GOVERNMENT OF THE DISTRICT OF COLUMBIA
DEPARTMENT OF TRANSPORTATION

MEMORANDUM

SUBJECT: ZC Case No. 17-10 – 5127-5131 Nannie Helen Burroughs Avenue NE (Strand Residences)

Figure 1 – Site Plan (Source: Applicant Plan Set, Sheet A-09, 10/26/17)

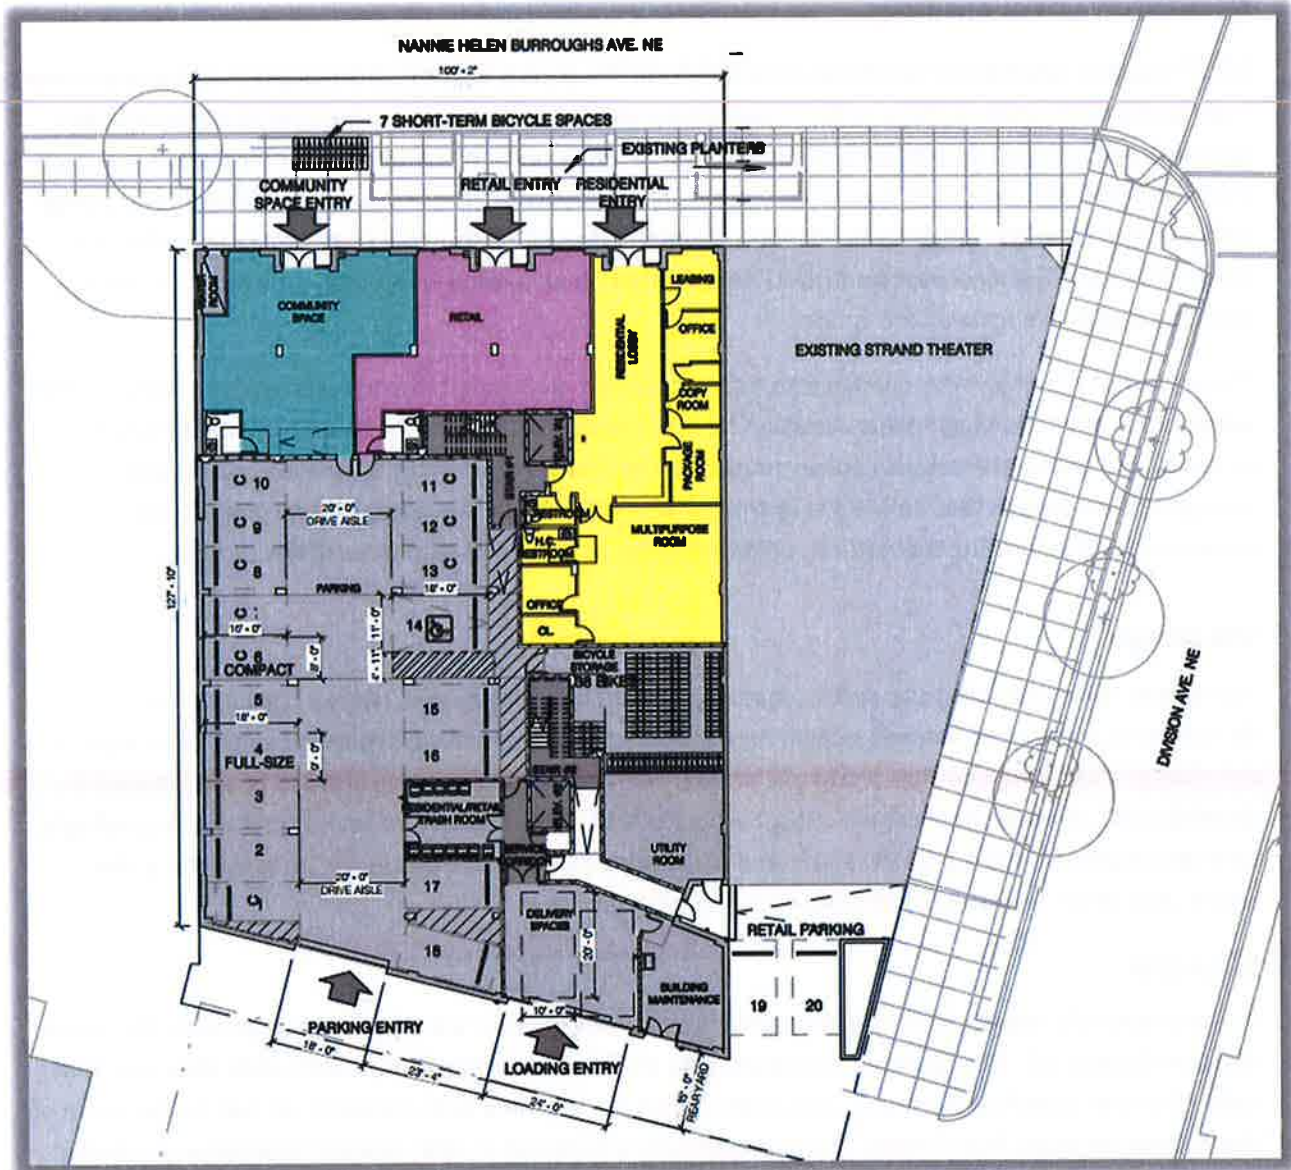
Primary vehicular access to the development is proposed to occur via a 14-foot rear private alley from Division Avenue NE. The Applicant is proposing to close the existing 15-foot rear public alley, use that strip of land as developable space, and create a new private alley approximately 40 feet to the south of the original location. DDOT notes that the Applicant is pursuing an alley closure application in parallel with this PUD case (Surveyor's Order 17-26544). DDOT generally finds this acceptable so long as a public access easement is in place so neighboring properties will not lose alley access or be precluded from accessing the new alley (due to any major changes in grade of the new alley for example) as a result of the shift and that trash trucks can adequately maneuver in the new alley. DDOT will provide more specific comments on the alley closure in a separate report to the Office of Surveyor.

Pedestrian access for the retail and community space portions of the project will be via entrances on Nannie Helen Burroughs Avenue NE. Residents of the property may either access the building via a third pedestrian entrance on Nannie Helen Burroughs Avenue NE or via the rear of the building in the vehicle parking area. Figure 1 below shows the site layout of the Strand Residences project.

- Final design and dimensions of new alley curb cut and closure of existing alley curb cut on Division Street NE;
- Install one (1) additional tree on Division Street NE near the location of the closed alley curb cut;

- Projection distances and clearance heights for proposed balconies on Nannie Helen Burroughs Avenue NE;
- Remove existing ground floor building projection from pedestrian walkway;
- Move bioretention planters on the southern side of Nannie Helen Burroughs Avenue NE to edge of curb to allow for a wider and straighter pedestrian clear path; and
- Determine final locations for the short-term bicycle spaces (inverted U-racks).

Figure 2 – Revised Loading Management Plan (Source: Grove/Slade Memo, Figure 2, 10/25/17)

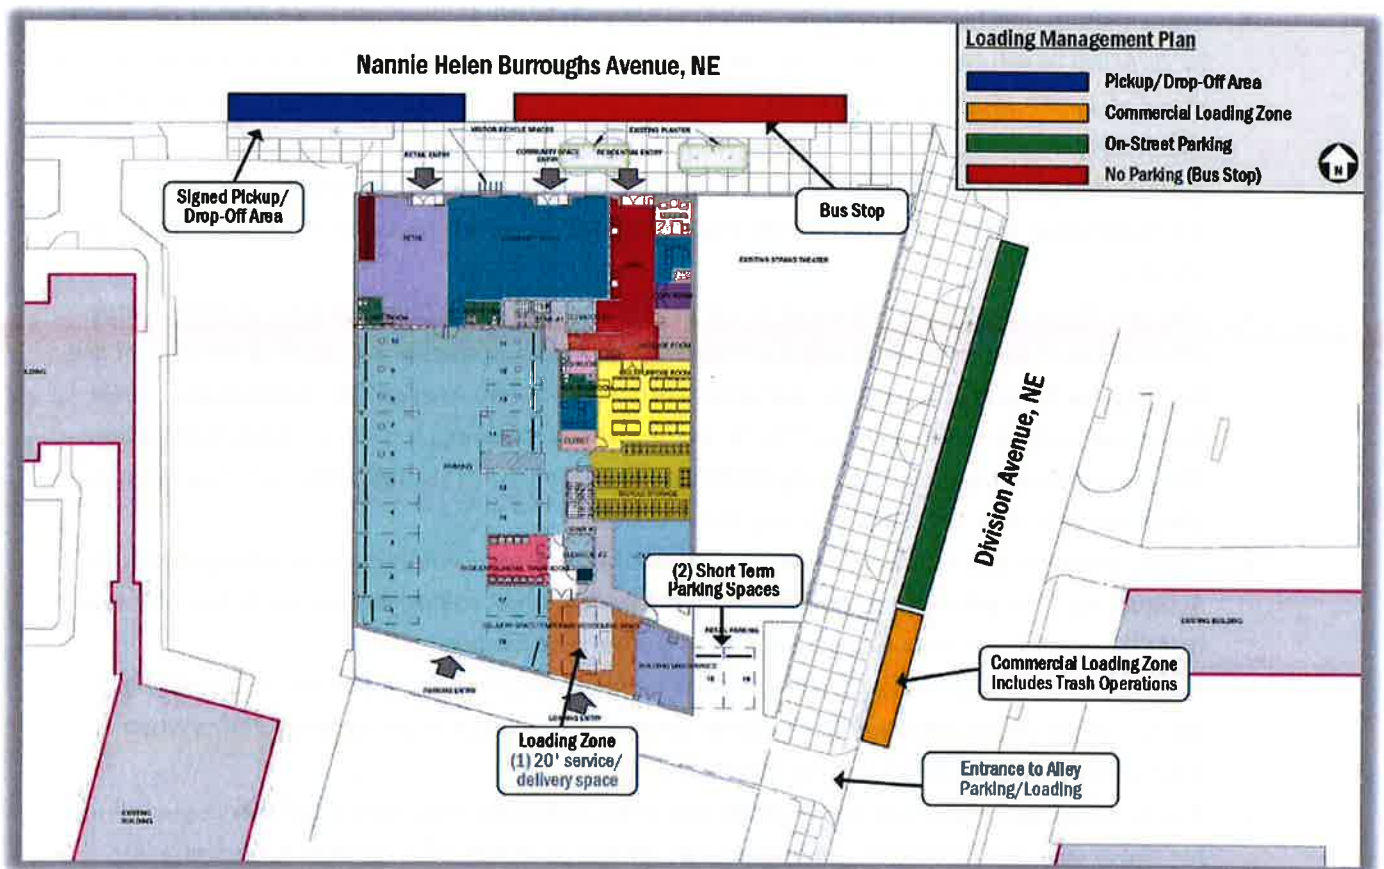
DDOT does not agree with the Applicant's proposal to create a signed pick-up/drop-off zone on Nannie Helen Burroughs Ave NE or a commercial loading zone on Division Avenue NE because DDOT would prefer not to lose a total of six (6) on-street vehicle parking spaces (three on each street) to accommodate trash pick-up that should occur on private property. Instead the Applicant should reconfigure the rear of the site or alter the design of the proposed private alley to accommodate trash trucks entirely on private property or within the alley and allow for only head-in/head-out movements. As currently designed, trash trucks would pull head-in to the alley and then back-out through public space to Division Avenue NE.

Additionally, references to the following elements should be removed from the proposed loading management plan:

- Commercial loading activity utilizing trucks greater than 20 feet shall utilize the proposed commercial loading zone alongside Division Avenue, NE.
- A dedicated pickup/drop-off area will be signed along NHB Avenue, NE, where parking is restricted at all times. The area will be adjacent to the main residential and retail entrances of the site.
- Trash collection operations will take place from the commercial loading zone alongside Division Avenue, NE. This will be accomplished with the utilization of rolling dumpsters to transfer waste from the trash room to the waste collection truck in the loading zone.

NE, which would result in the loss of six (6) on-street vehicle parking spaces. Instead DDOT expects the Applicant to make revisions to the private alley and/or building design in order to allow trash trucks to access the property via the alley making only head-in and head-out movements.

DDOT is in agreement with the Applicant on the requested loading relief for a residential loading berth and the use of 'emergency no parking' signs for on-street move-ins and move-outs on the condition that the proposed loading management plan being implemented. Additionally, the loading management plan should be revised to strike all elements referencing the proposed commercial loading zone or pick-up/drop-off zone.

Figure 7 – Existing Pedestrian Facilities (Source: CTR, Gorove/Slade, Figure 21, 10/2/17)

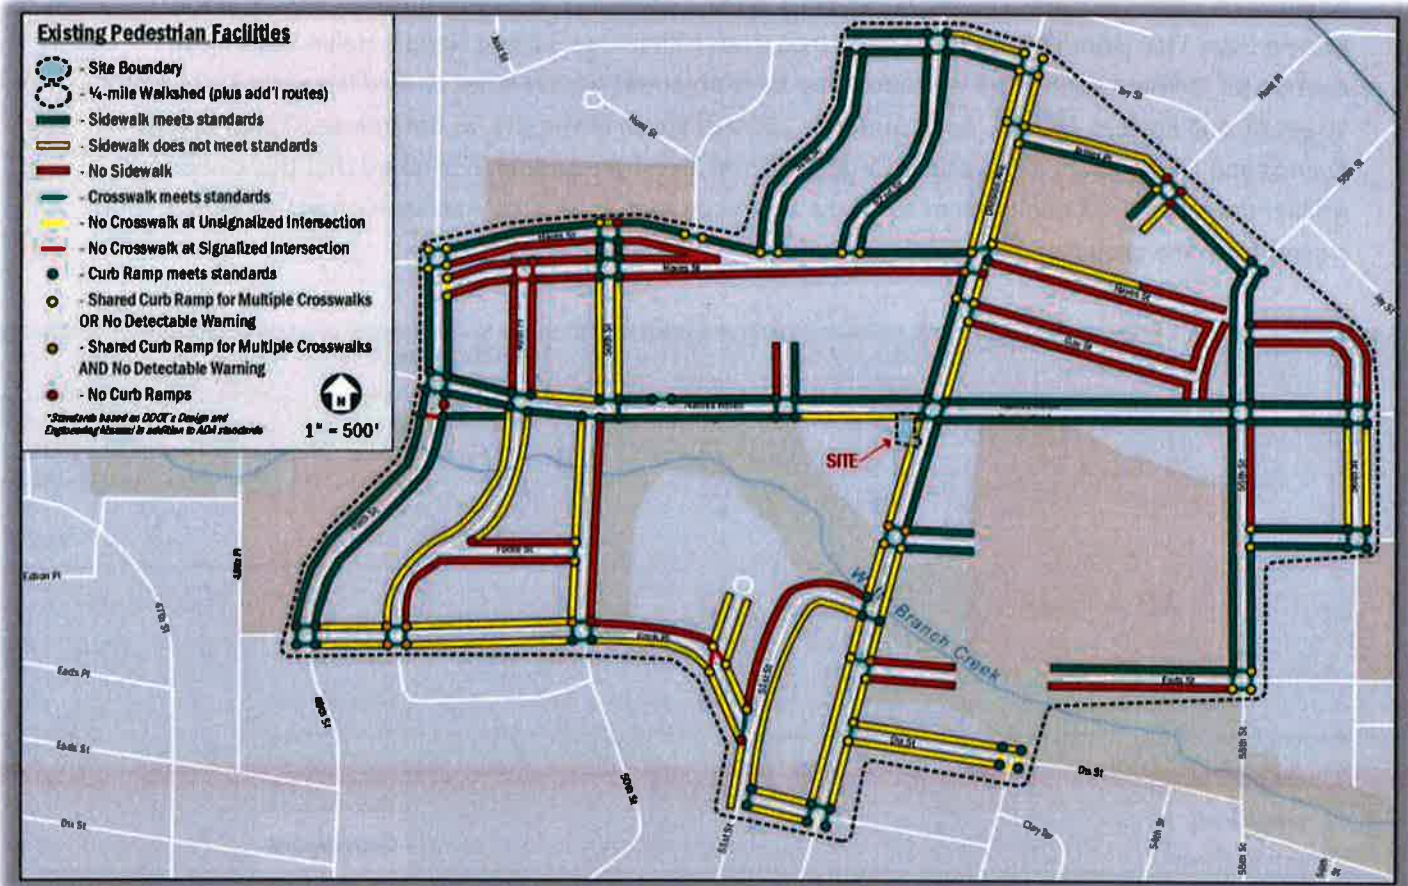
The Applicant’s existing inventory of the pedestrian infrastructure in the vicinity of the sites, as shown in Figure 7 below, stretches of substandard sidewalks along the site frontages on both Nannie Helen Burroughs Avenue and Division Avenue NE. While there are several missing or substandard segments of sidewalk and curb ramps in the broader area, the existing pedestrian network along major pathways to schools and attractions is generally adequate.

DDOT expects that the Applicant will reconstruct the public space on both Nannie Helen Burroughs Avenue NE (from the corner to the western property line) and Division Street NE (from the corner south to the proposed private alley) and upgrade any pedestrian facilities to current DDOT standards.
